ALERT SERVICE BULLETIN

TITLE: Tail Rotor Drive - Shaft - Improved geometry of the tail boom rear drive shaft

Model:	EC130
Version:	T2
Component affected:	350A34-5020-00
Helicopters POST MOD:	079809
Helicopters PRE MOD:	0790006

GENERAL ILLUSTRATION

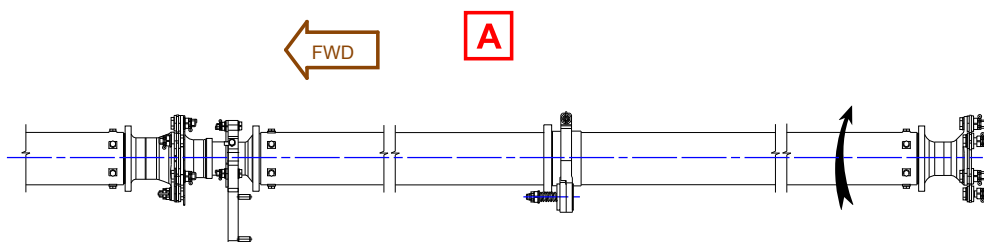
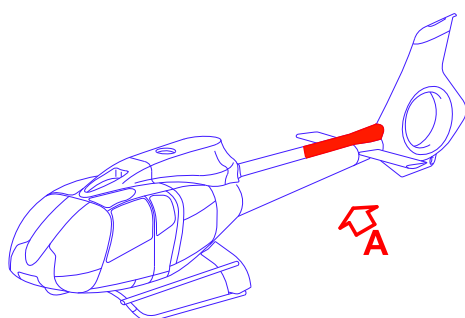
Several in-service incidents were reported to AH concerning degradation of the intermediate tail drive shafts support on the H130 equipped with a new tail boom post ECP 079809 featuring a new tail drive shaft assembly with a single bearing. The damage consists of loose/failed rivets on the bearing support, in some limited cases occurrence of cracks in the supporting structure and occasional wear of the splines in the connection between the two drive shafts. AH had initiated extensive investigations and identified the root cause of these events. As a corrective measure, the main objective of this ALERT SERVICE BULLETIN is to replace the current tail boom rear drive shaft by a new rear drive shaft with an improved geometry.

This ALERT SERVICE BULLETIN provides the instruction to the replacement of the tail boom rear drive shaft.

- 3.1.1. Refer to Task [AMM 65-11-01,4-3](#) and remove the shaft assy.
- 3.1.2. Refer to Task [AMM 65-11-01,4-4](#) and install the Shaft assy, aft 350A34-5020-01.
